Technical Service Information

RE4RO1A BEARING CHANGE

Figure 1

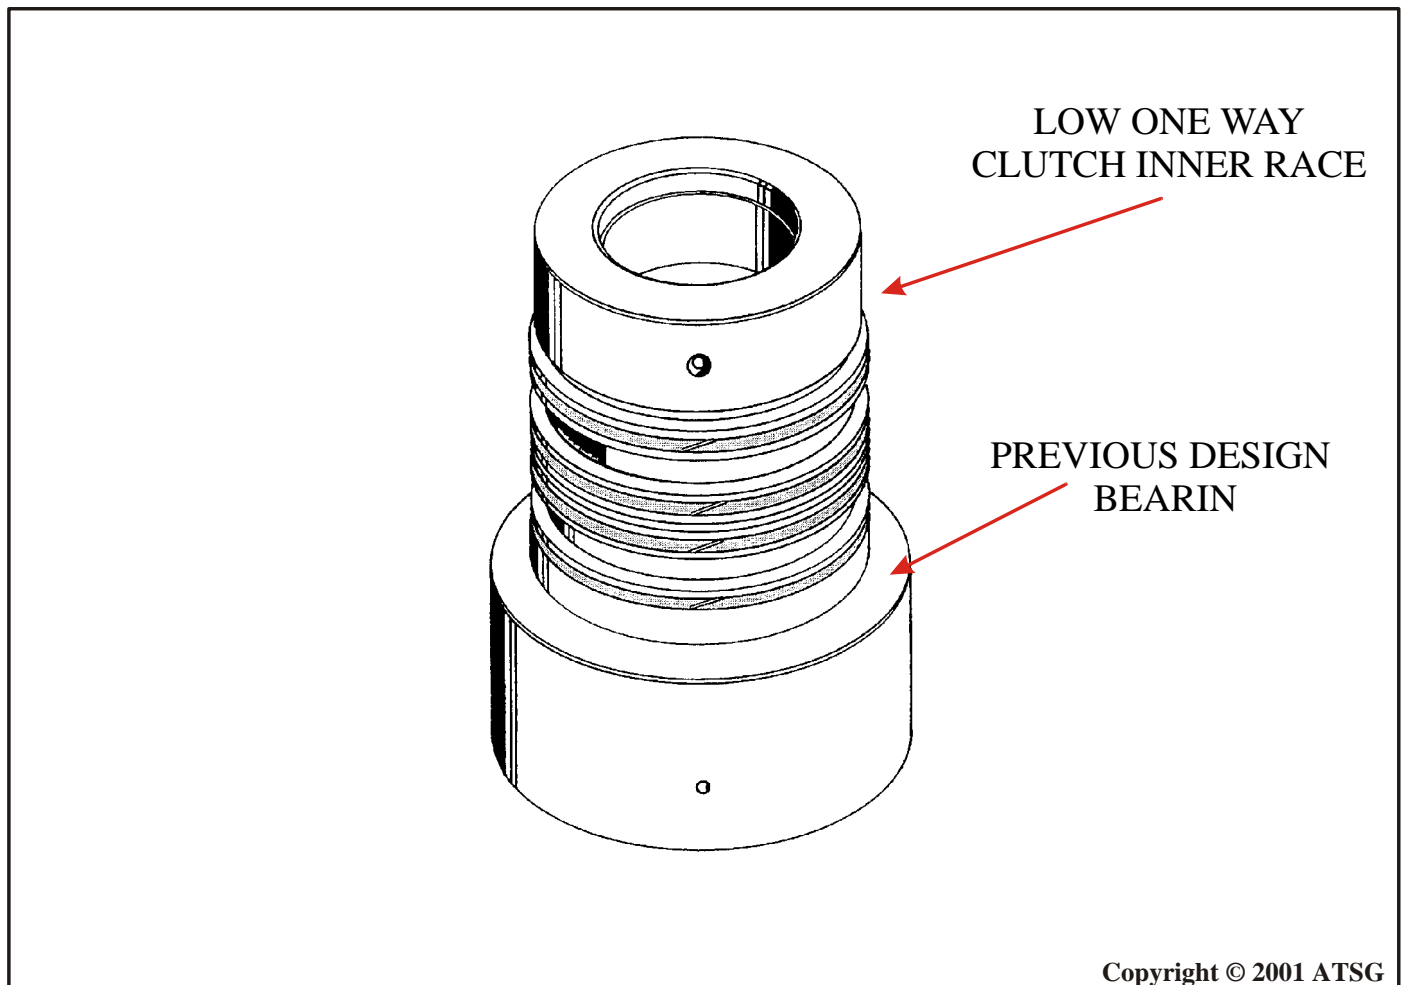
CHANGE: The three piece needle bearing located at the rear of the low one way clutch inner race in RE4RO1A transmissions has changed (See Figure 1).

Figure 2

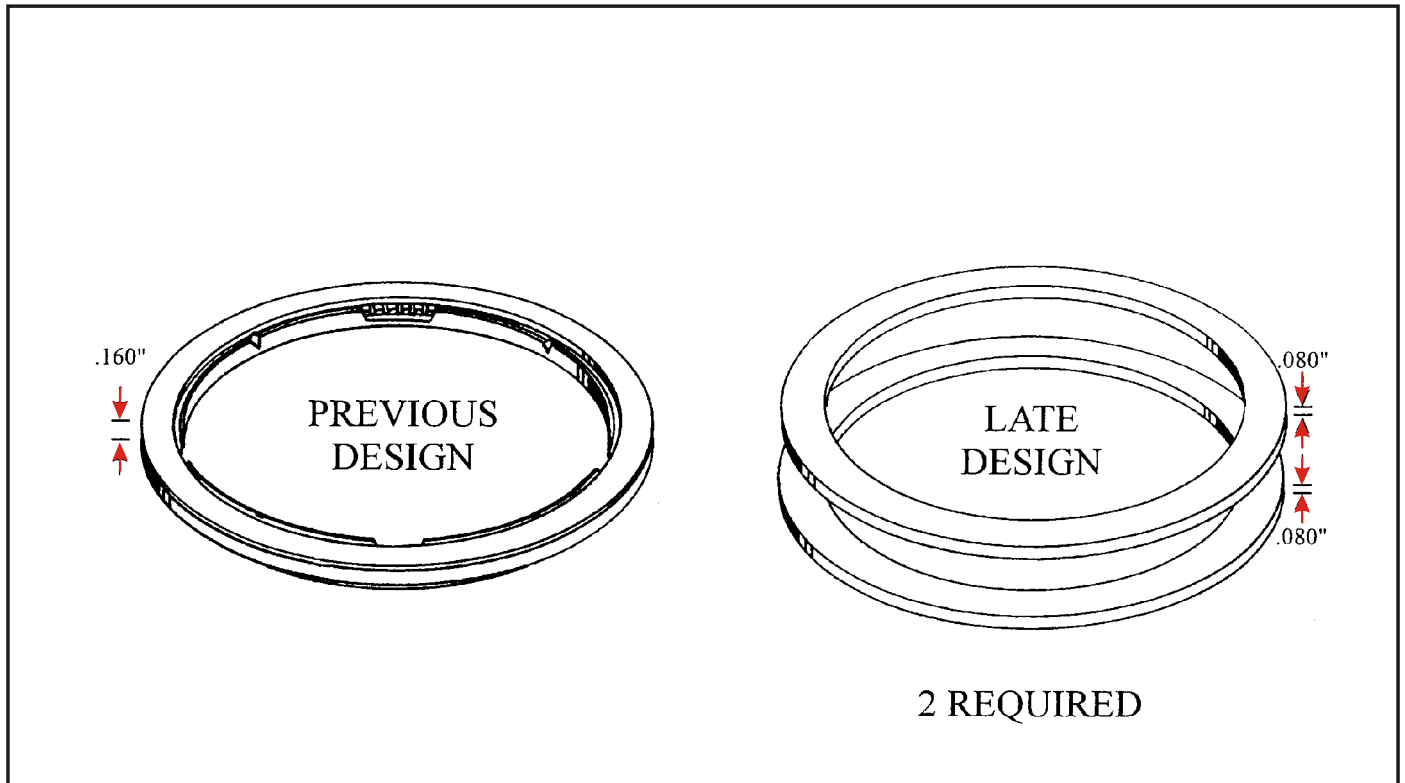
PARTS AFFECTED:
The previous design 3 piece bearing has been replaced by 2 thrust washers (See Figure 2).

INTERCHANGEABILITY:
The 2 new design thrust washers will retro fit backwards. These thrust washers must be used in a pair. If not, premature bearing failure, lubrication and or end play problems **will** arise.

SERVICE INFORMATION:
THRUST WASHER (NEW DESIGN-2 REQUIRED).....31508-41X01
